# Western Harbour Tunnel and Warringah Freeway Upgrade

Introduction, overview of consultation and submissions received, refinements and clarifications

September 2020

**Figure A4-1 Child care centres in the vicinity of Victoria Rd, Rozelle (update to Figure 21-4 of the environmental impact statement and Figure 4-10b of Appendix U (Technical working paper: Socio-economic assessment))**

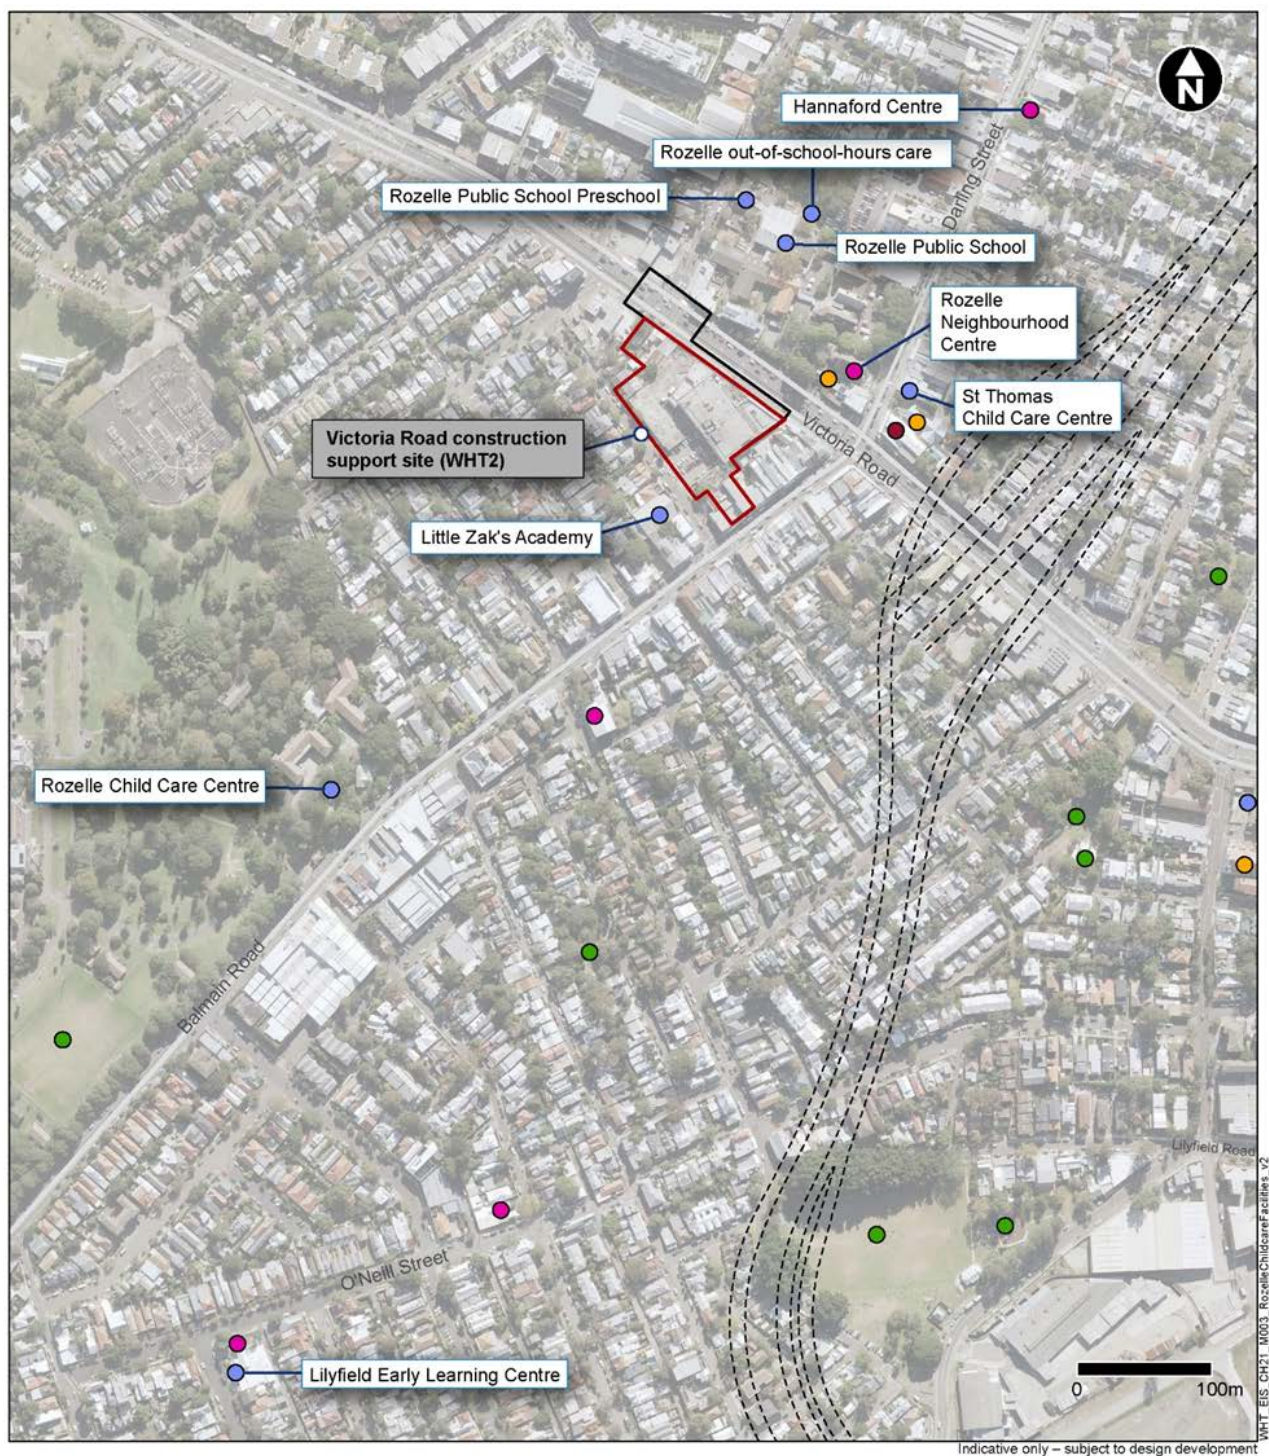
These childcare centres are presented in Figure A4-1 below which provides an expanded area to Figure 21-4 of the environmental impact statement and Figure 4-10b of Appendix U (Technical working paper: Socio-economic assessment).

**Figure A4-4 Main corridor alternatives (update to Figure 4-5 and E9 of the environmental impact statement)**

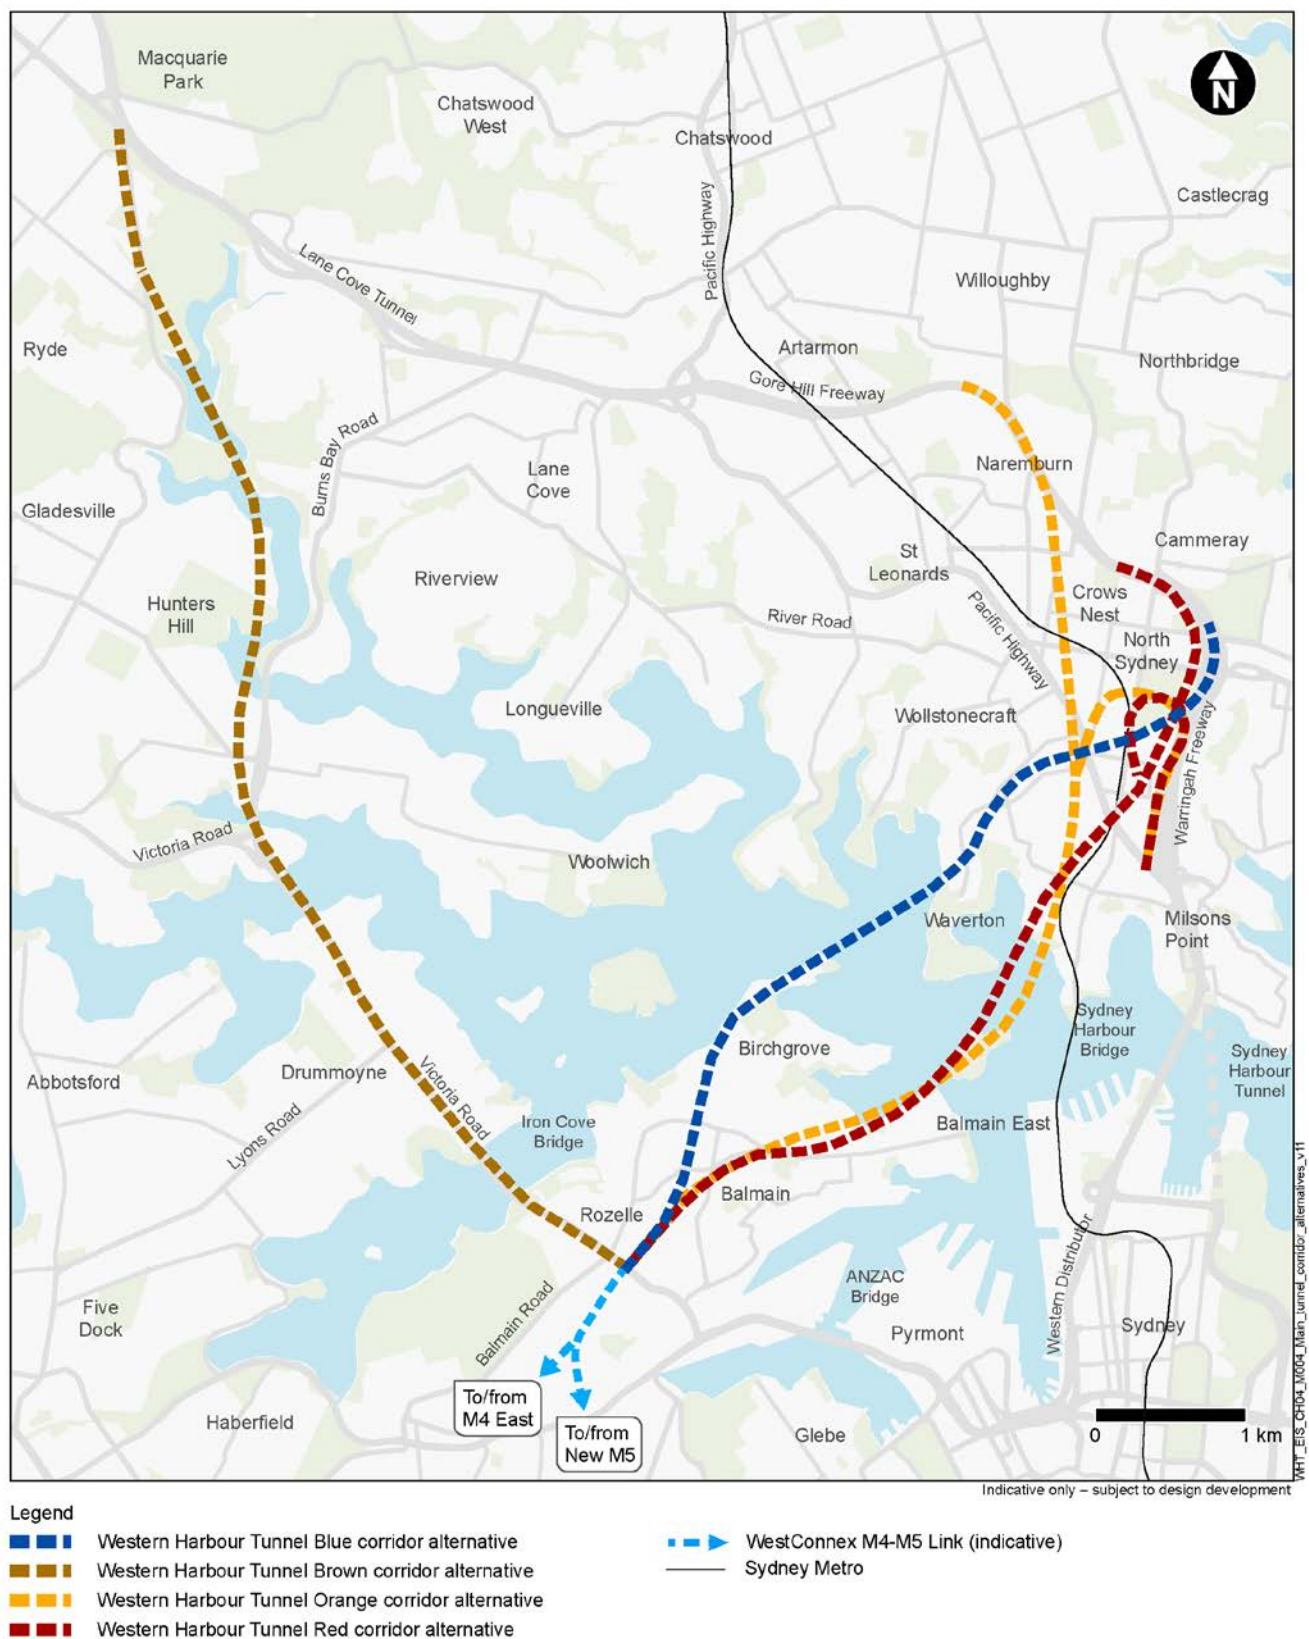
| Chapter/Appendix reference  | Error/discrepancy   | Clarification  |
|---|---|--|
| <b>Chapter 4 (Project development and alternatives), Figure 4-5, Figure 4-7 and Figure 4-9, and Chapter 0 (Executive summary) of the environmental impact statement</b>             | Inconsistency between the shortlisted main corridor alternatives for the project presented in Figure 4-5, Figure 4-7 and Figure 4-9, and Chapter 0 (Executive summary) of the environmental impact statement. | Figure A4-4 below presents the shortlisted main corridor alternatives for the project. This figure replaces Figure 4-5 and Figure E9 in the environmental impact statement.  |

**Figure A4-5 Change in maximum 24-hour mean  $PM_{10}$  concentration at community receivers (update to Figure 12-14 of the environmental impact statement)**

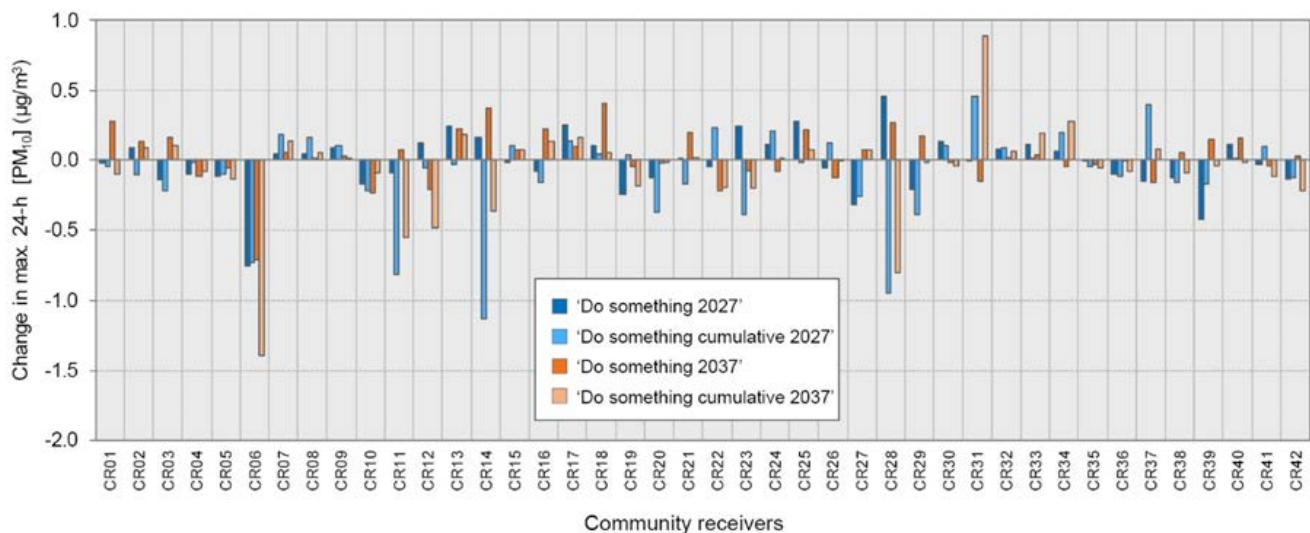
| Chapter/Appendix reference  | Error/discrepancy  | Clarification  |
|---|--|--|
| <b>Chapter 12 (Air Quality), Figure 12-4 and Figure 12-17</b>                                     | The figure legends are obscuring some data.  | Figure 12-14 has been updated as Figure A4-5 and Figure 12-17 has been updated as Figure A4-6 of this submissions report.  |

Figure A4-7 Total traffic emissions in the GRAL domain (update to Figure 8-7 of Appendix H (Technical working paper: Air quality))

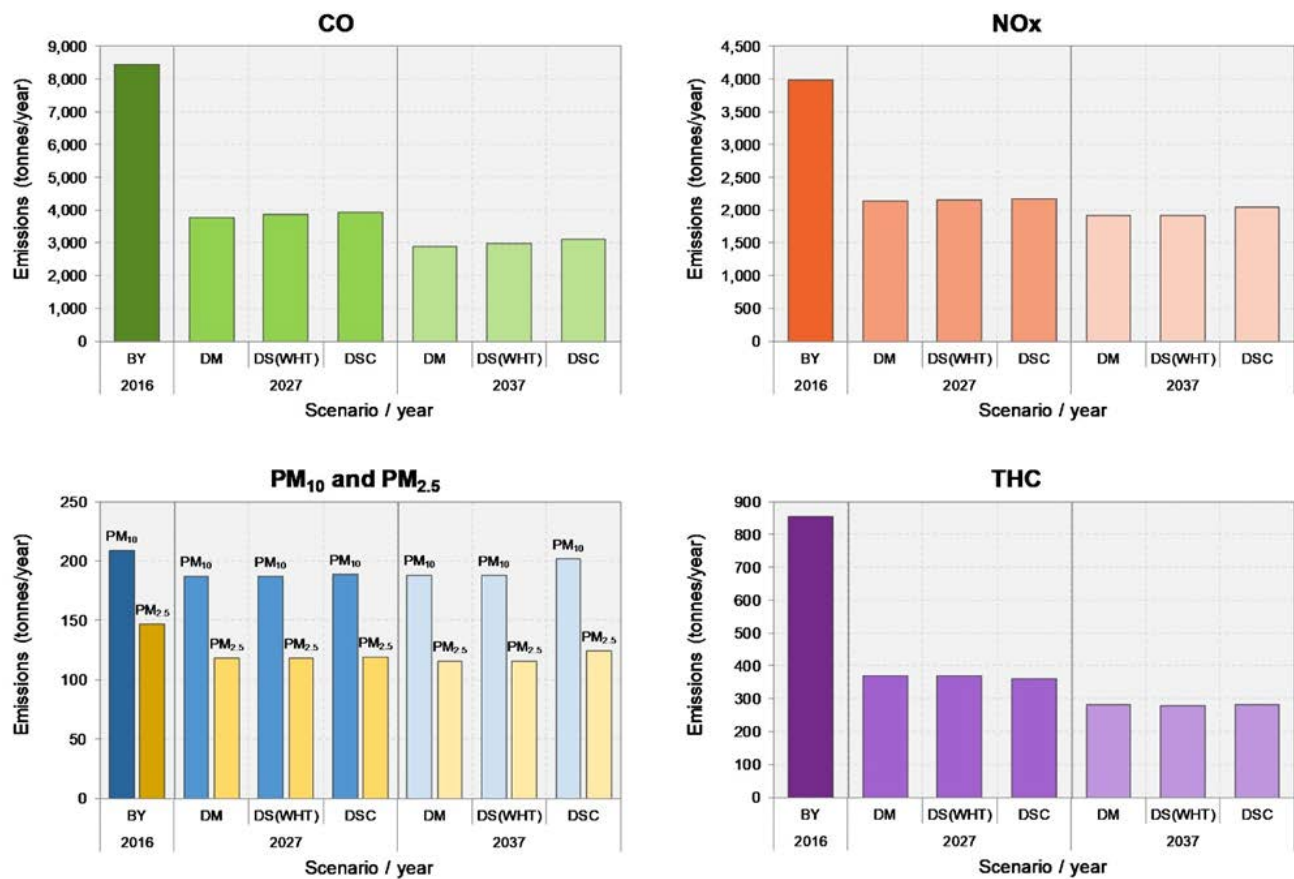
| Chapter/Appendix reference  | Error/discrepancy  | Clarification  |
|---|--|--|
| <b>Appendix H (Technical working paper: Air quality), Section 8.2.4, Figure 8-7 and Table 8-8</b> | There is a discrepancy between the graph bars show in Figure 8-7 and the values shown in Table 8-8.  | The values shown in Table 8-8 are correct. The correct figures are shown in Figure A4-7 of this submissions report.  |
